## Technical Memorandum

**TO:** Mr. Alan Day, General Manager  
Brazos Valley Groundwater Conservation District

**SUBJECT:** Hydrogeologic Review of Transport Permit Applications for Mr. James Brien, Cula d’Brazos LLC, Ely Family Partnership LP, Fazzino Investments LP, RH2O LLC, Mr. Clifford A. Skiles III, and L. Wiese Moore LLC

Figure 10. AGS simulated Simsboro Aquifer DFC drawdown (2000 – 2070).

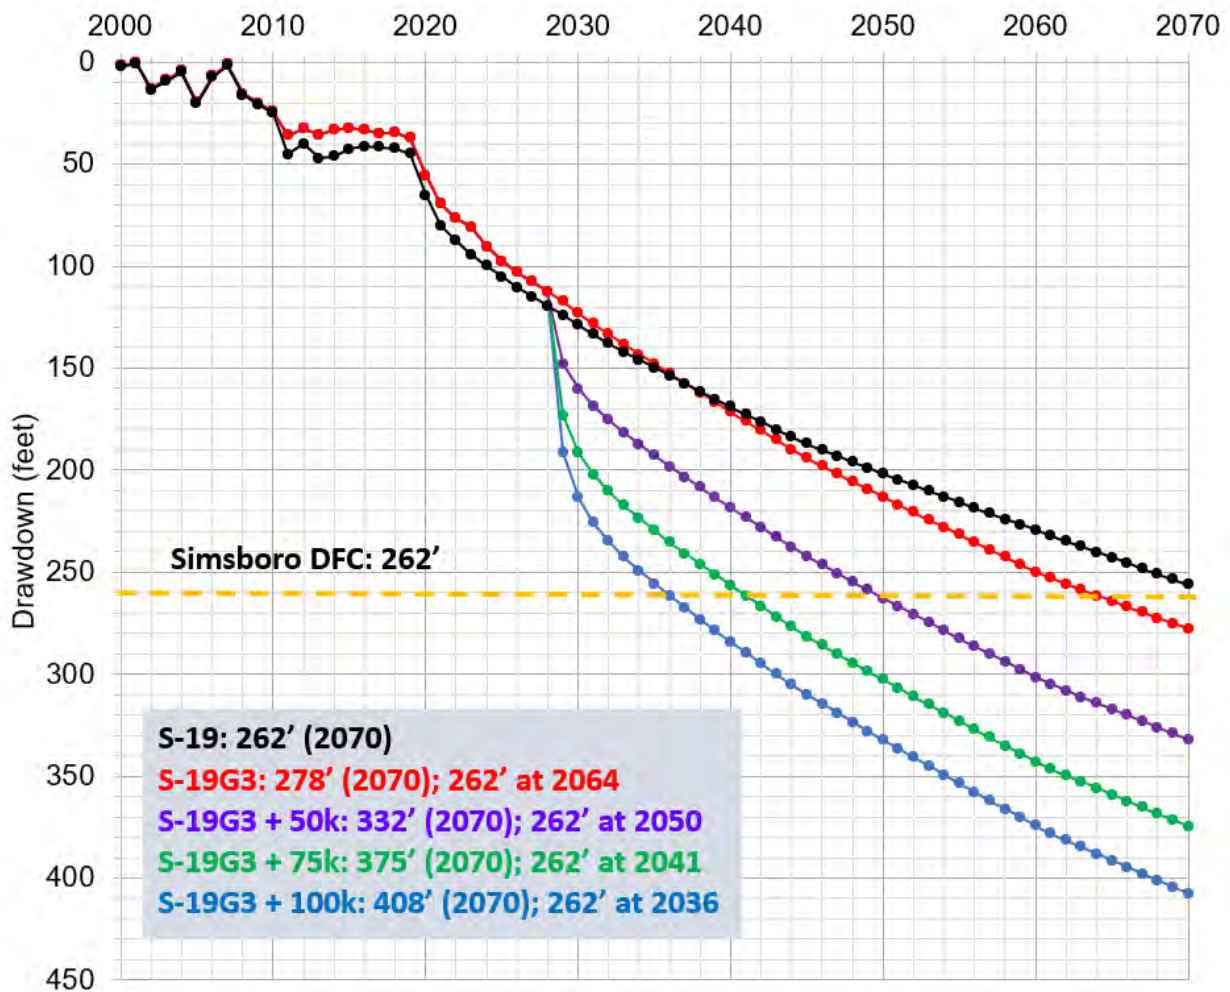
Effects due to increases in the Simsboro Aquifer pumping can be observed in the BVGCD DFC drawdown (2000 to 2070) estimates in the Carrizo Aquifer, Calvert Bluff Formation and Hooper Formation as shown in Figures 11, 12 and 13, respectively. S-19G3 includes a slight decrease in the Carrizo pumping in the vicinity of the Vista Ridge project. However, most of the differences in the BVGCD DFC estimates in the Carrizo, Calvert Bluff and Hooper can be attributed to the increases in simulated Simsboro Aquifer pumping. Simulated drawdown at 2070 increases and the date which the drawdown reaches the currently adopted aquifer DFC occurs sooner. Figures 11, 12 and 13 include text to indicate the simulated drawdowns at 2070 and the year at which the drawdown reaches the current DFC for each aquifer. Although not included herein, our review of the volumetric model budget indicates that increased leakage occurs from aquifers above and below the Simsboro with increased pumping in the Simsboro.

Figure 17. AGS estimate of the number of BVGCD permitted or registered Simsboro wells that will need to be redrilled or have the pump lowered based on the S-19G3 + 50,000 ac-ft/yr, S-19G3 + 75,000 ac-ft/yr and S-19G3 + 100,000 ac-ft/yr pumping scenarios.

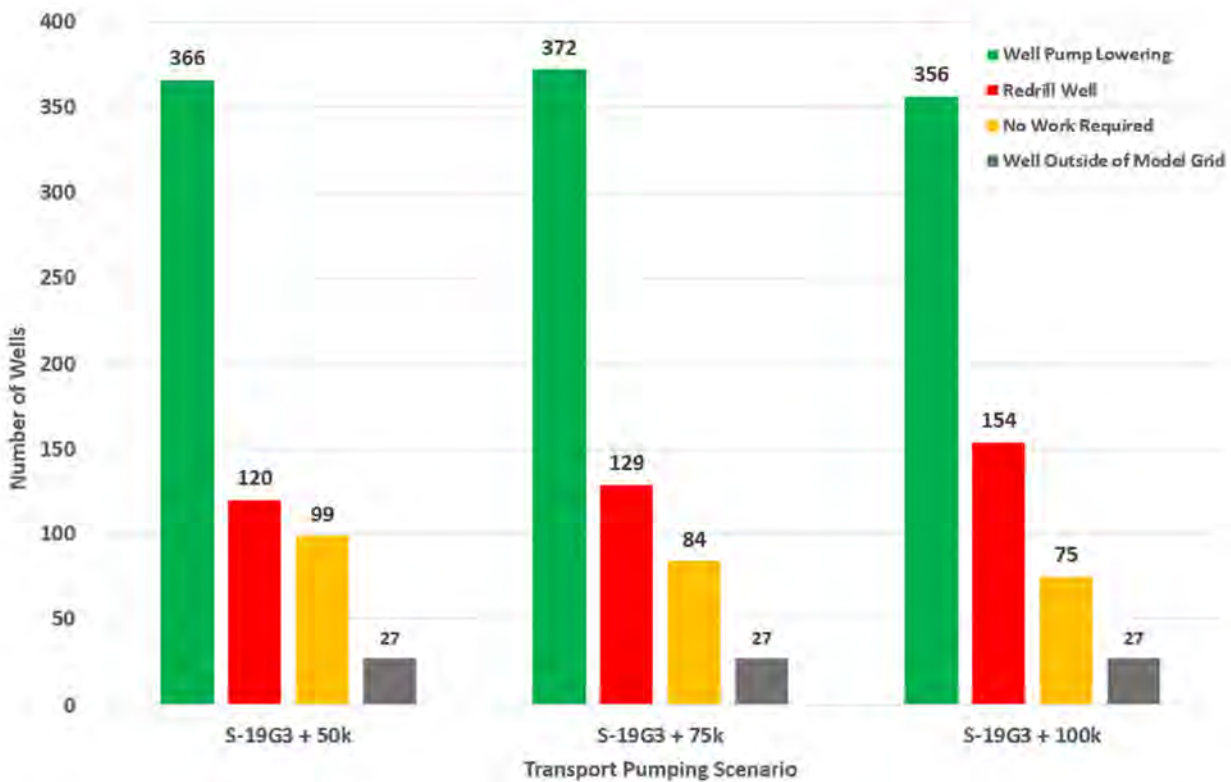
Figure 17 shows the estimated number of BVGCD permitted and registered Simsboro wells that will need to be redrilled or have the pump lowered based on the S-19G3 + 50k, S-19G3 + 75k and S-19G3 + 100k pumping scenarios. Figures 18, 19 and 20 show the locations of BVGCD permitted or registered Simsboro wells that need to be redrilled, have the pump lowered or require no additional work based on the S-19G3 + 50k, S-19G3 + 75k and S-19G3 + 100k pumping scenarios, respectively.

Figure 2. Map of Wells Near the Proposed Wells

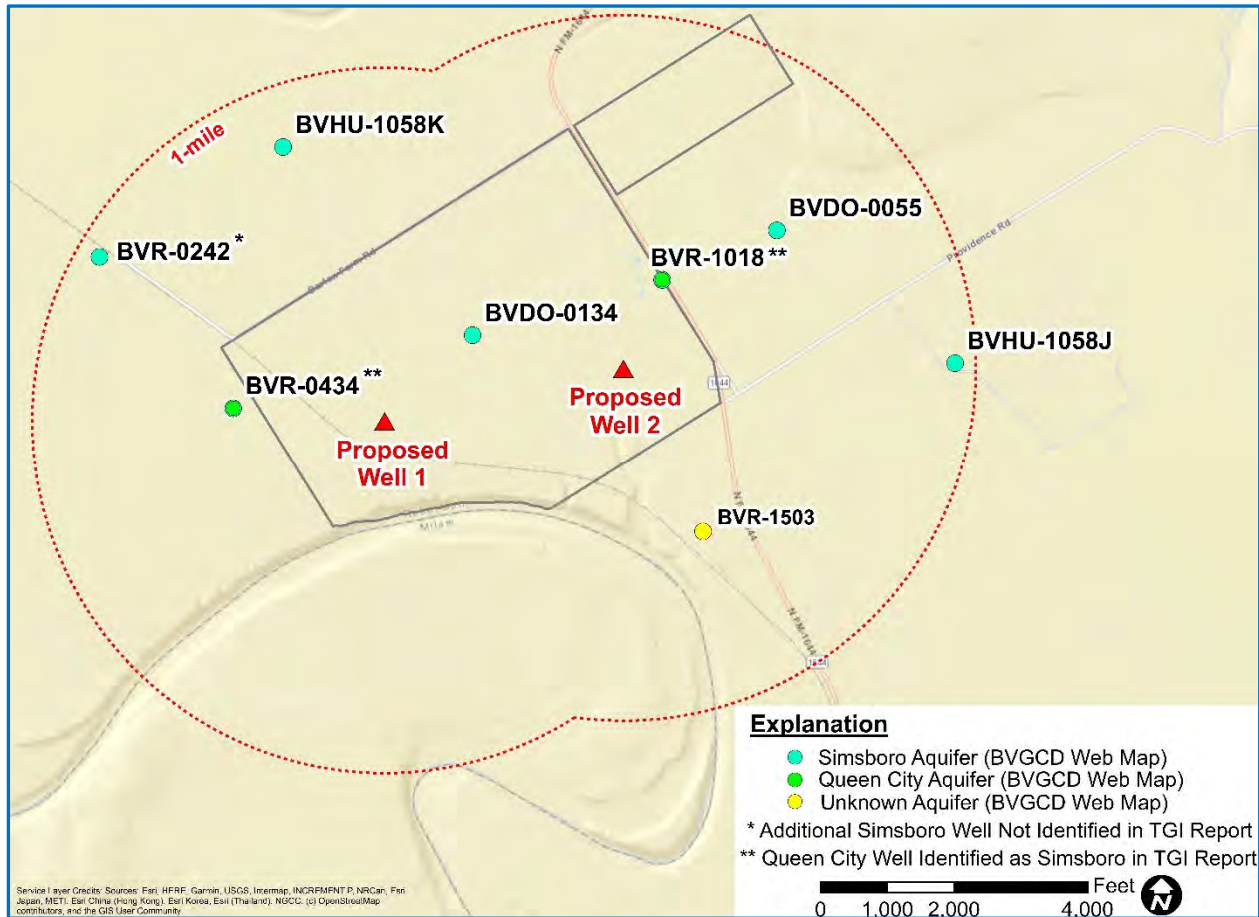
BVR-0242 is identified as a Simsboro well on the BVGCD Web Map and is located within one mile of the proposed Brien 1 well location. BVR-0242 is not included in Table 2 of the TGI report or shown on Figure 2 in the Aquifer Evaluation Report. The BVR-0242 State of Texas Well Report (Tracking Number 495742) shows the well screened interval as 587 to 607 feet below ground level (-302 to -322 feet rsl), which would indicate that the well is completed in the Simsboro. BVR-0242 is subsequently not included in the model simulation discussion or results.

Figure 2. AGS This Analytical Simulated Drawdown After Proposed Cula d’Brazos LLC Pumping of 12,000 ac-ft/yr for 10-Years

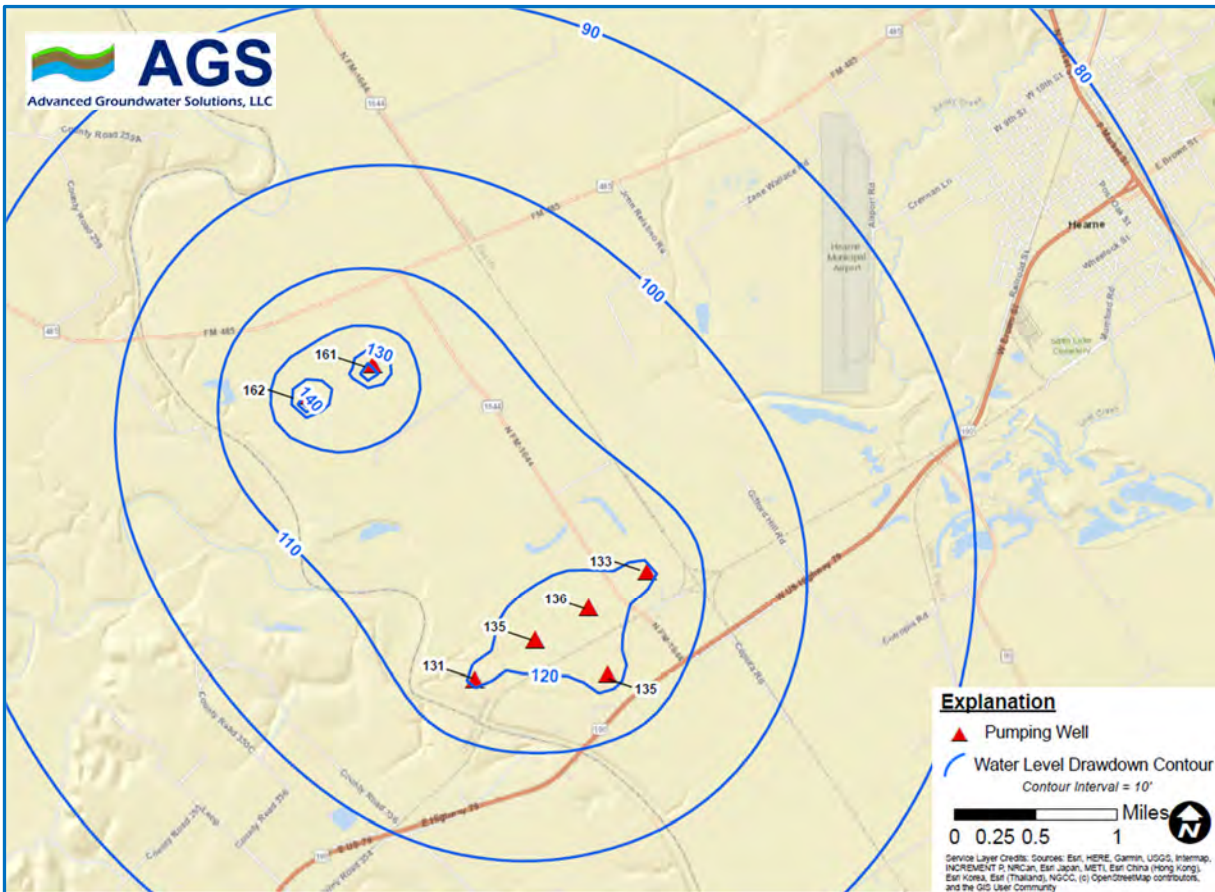
AGS was able to generally recreate the 1-year simulation results of the TGI analytical modeling. The TGI 10-year analytical simulation appears to underestimate the drawdown compared to simulations performed by AGS using the aquifer parameters as described above. Simulated drawdown could be less if TGI used a larger storage value in the 10-year simulation. Figure 2 below shows the estimated AGS analytical modeling drawdown contours that result from pumping 12,000 ac-ft/yr for 10-years.

Figure 2. AGS Theis Analytical Simulated Drawdown After Proposed Ely Family Partnership Pumping of 13,873 ac-ft/yr for 10-Years

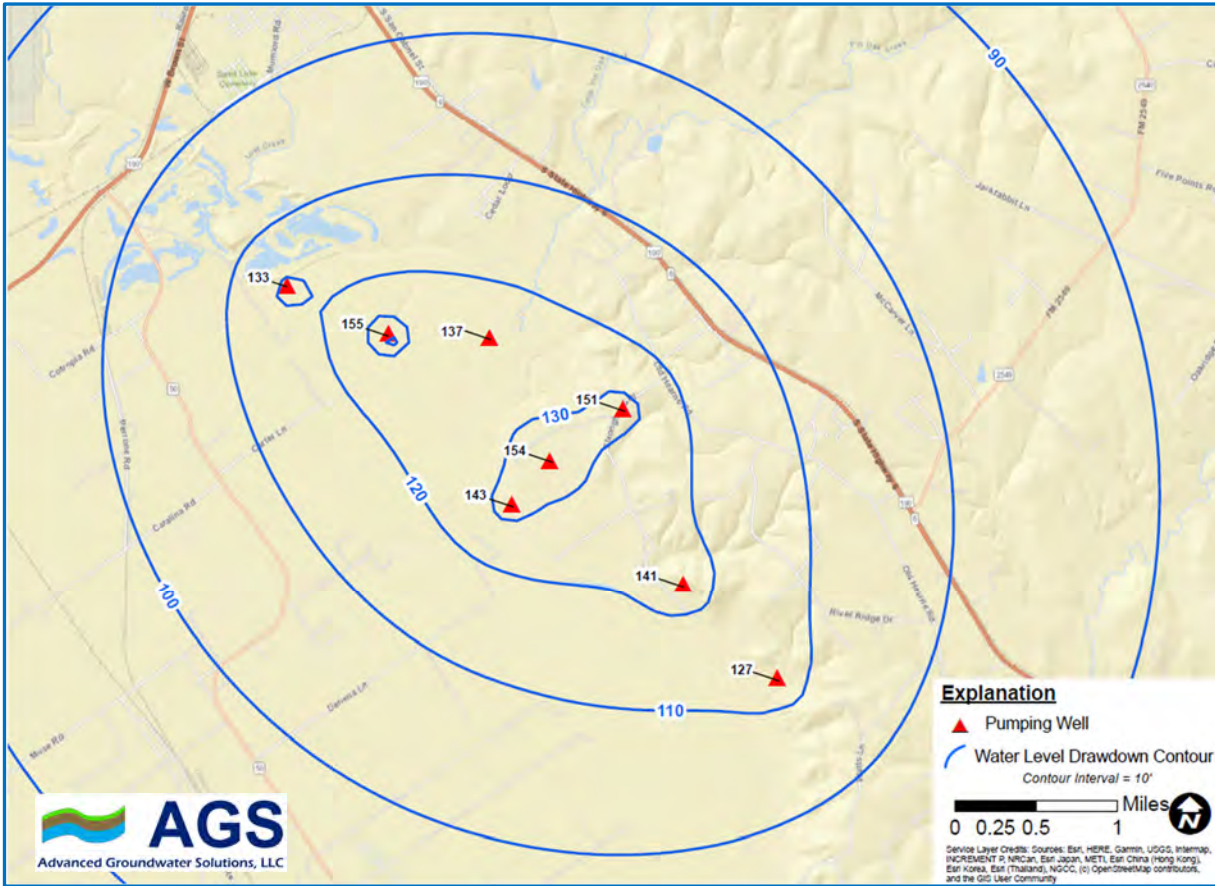
AGS was able to generally recreate the 1-year simulation results of the TGI analytical modeling. The TGI 10-year analytical simulation appears to underestimate the drawdown compared to simulations performed by AGS using the aquifer parameters as described above. Simulated drawdown could be less if TGI used a larger storage value in the 10-year simulation. Figure 2 below shows the estimated AGS analytical modeling drawdown contours that result from pumping 13,873 ac-ft/yr for 10-years.

Figure 2. AGS This Analytical Simulated Drawdown After Proposed Fazzino Investments LP Pumping of 10,348 ac-ft/yr for 10-Years

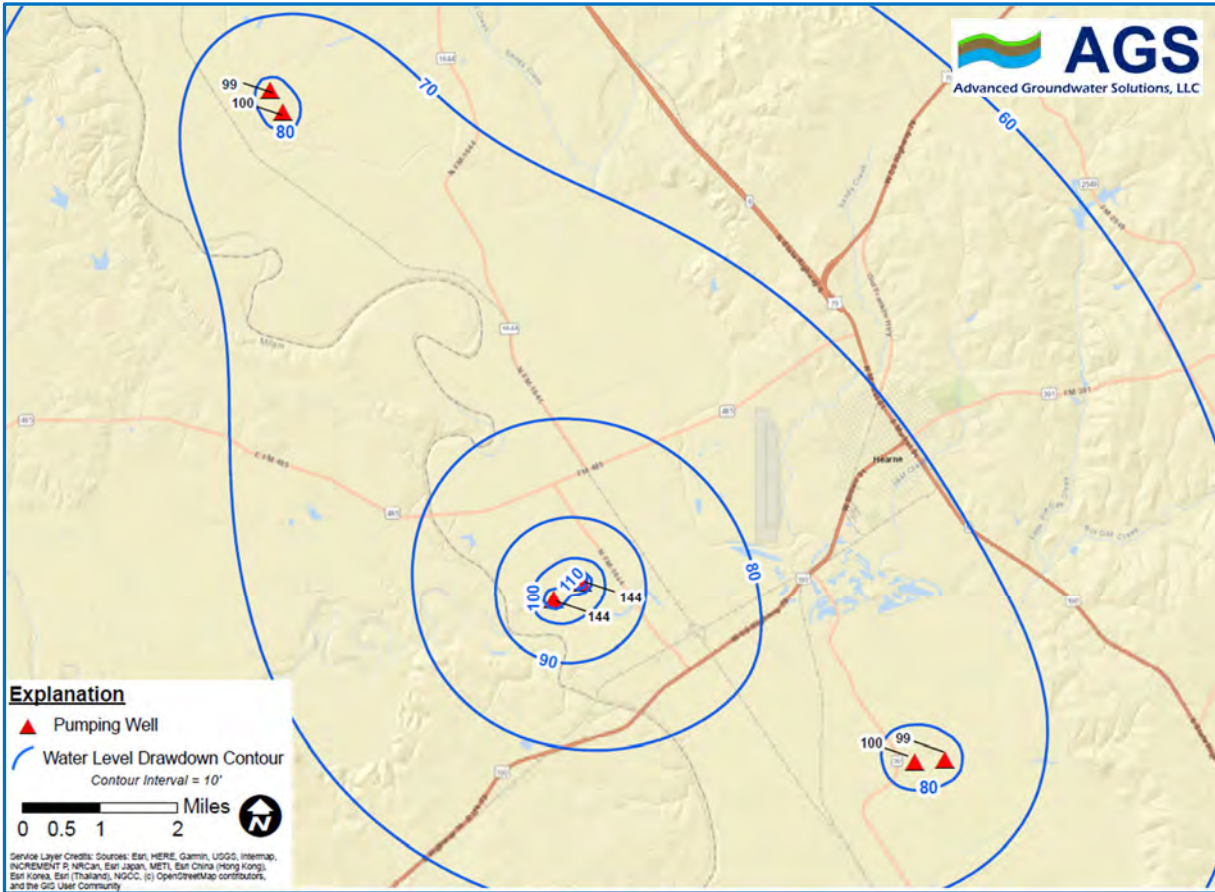
AGS was able to generally recreate the 1-year simulation results of the TGI analytical modeling. The TGI 10-year analytical simulation appears to underestimate the drawdown compared to simulations performed by AGS using the aquifer parameters as described above. Simulated drawdown could be less if TGI used a larger storage value in the 10-year simulation. Figure 2 below shows the estimated AGS analytical modeling drawdown contours that result from pumping 10,348 ac-ft/yr for 10-years.

Figure 2. AGS Theis Analytical Simulated Drawdown After Proposed RH2O Pumping of 8,130 ac-ft/yr for 10-Years

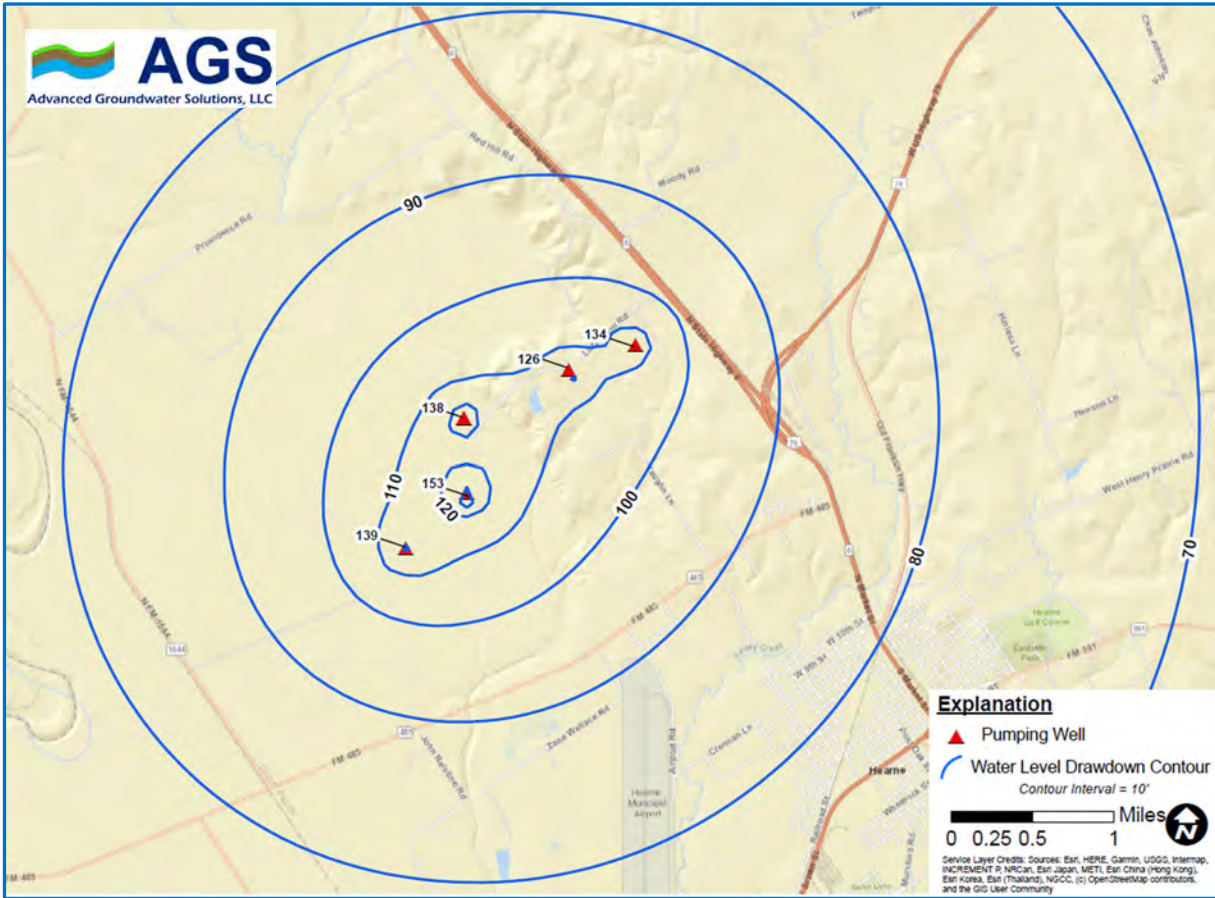
AGS was able to generally recreate the 1-year simulation results of the TGI analytical modeling. The TGI 10-year analytical simulation appears to underestimate the drawdown compared to simulations performed by AGS using the aquifer parameters as described above. Simulated drawdown could be less if TGI used a larger storage value in the 10-year simulation. Figure 2 below shows the estimated AGS analytical modeling drawdown contours that result from pumping 8,130 ac-ft/yr for 10-years.

Figure 2. GAM Simulated Drawdown Effects in Simsboro Aquifer After Proposed Skiles Pumping of 4,800 ac-ft/yr for 1-Year

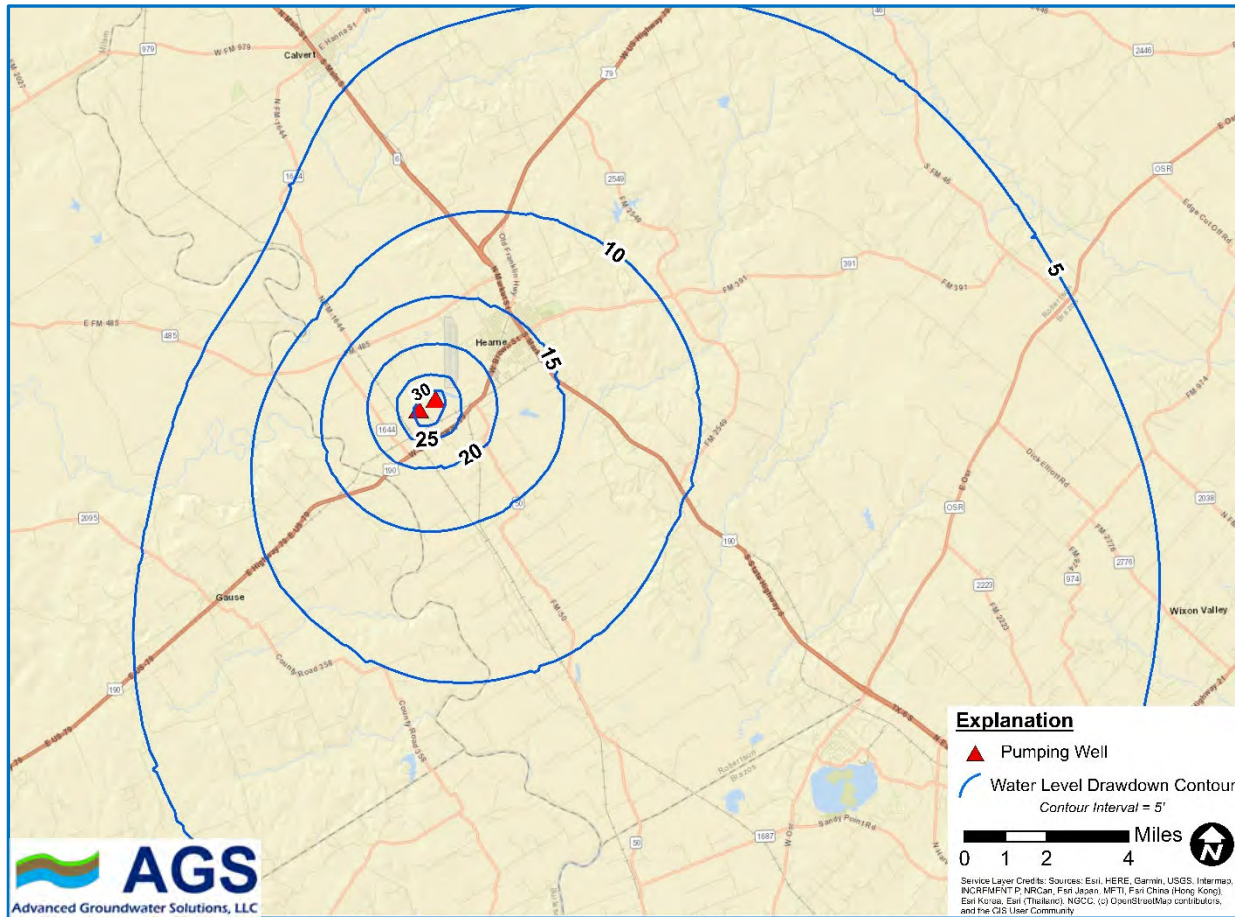
Figure 2 shows the AGS estimated effects that result from simulation of the requested 4,800 ac-ft of pumping from the Simsboro Aquifer after one year. AGS GAM simulated one year drawdown is estimated to range from about 22 to over 30 feet within one mile from the simulated Skiles wells and about 6 to 13 feet at a distance of five miles from the Skiles wells, depending on the direction from the proposed wells.

Figure 3. GAM Simulated Drawdown Effects in Simsboro Aquifer After Proposed Skiles Pumping of 4,800 ac-ft/yr for 10-Years

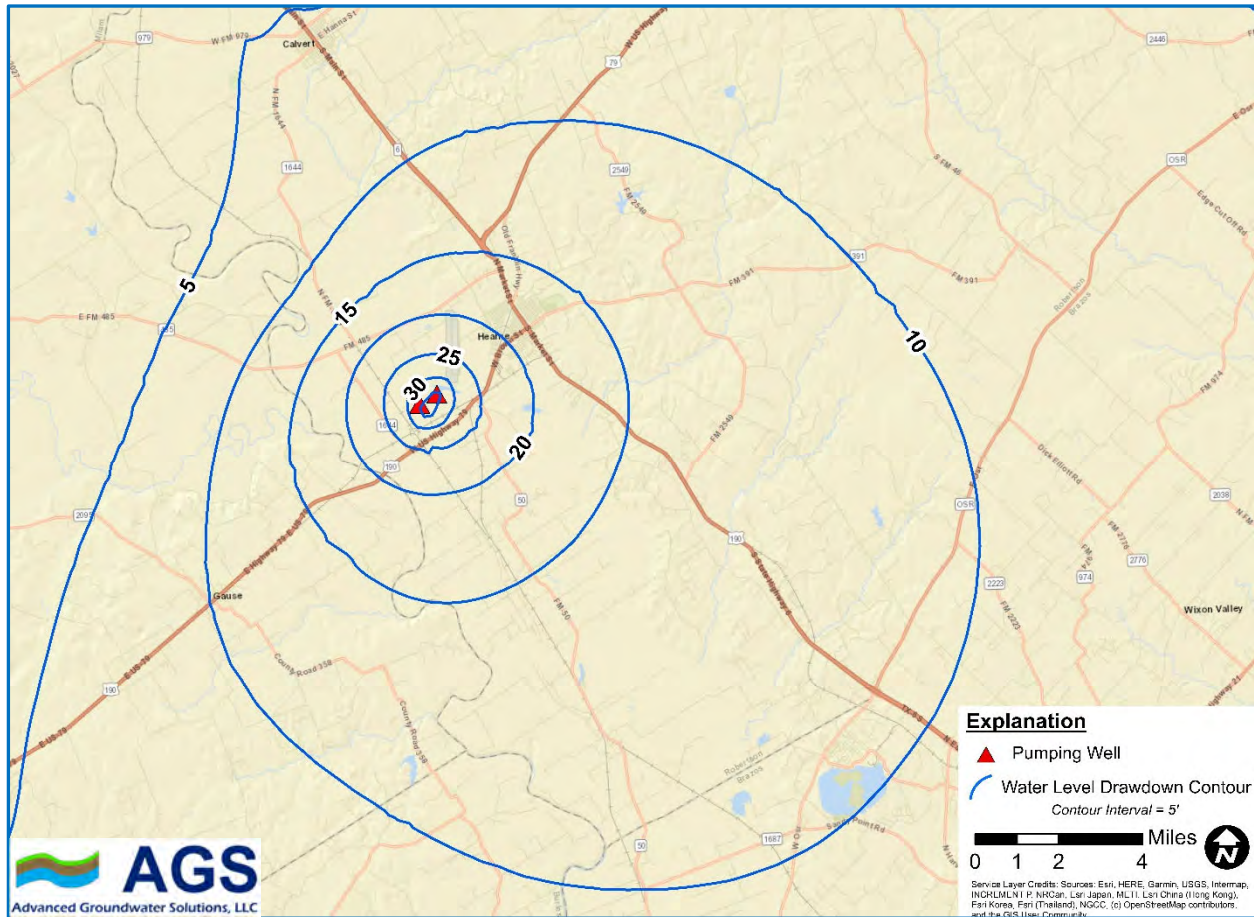
Figure 3 shows the AGS estimated effects that result from simulation of the requested 4,800 ac-ft of pumping from the Simsboro Aquifer after 10 years. AGS GAM simulated 10-year drawdown is estimated to be about 24 to over 35 feet within one mile from the simulated Trey Skiles wells and about 8 to 14 feet at a distance of five miles from the proposed and existing Trey Skiles wells, depending on the direction from the proposed wells.
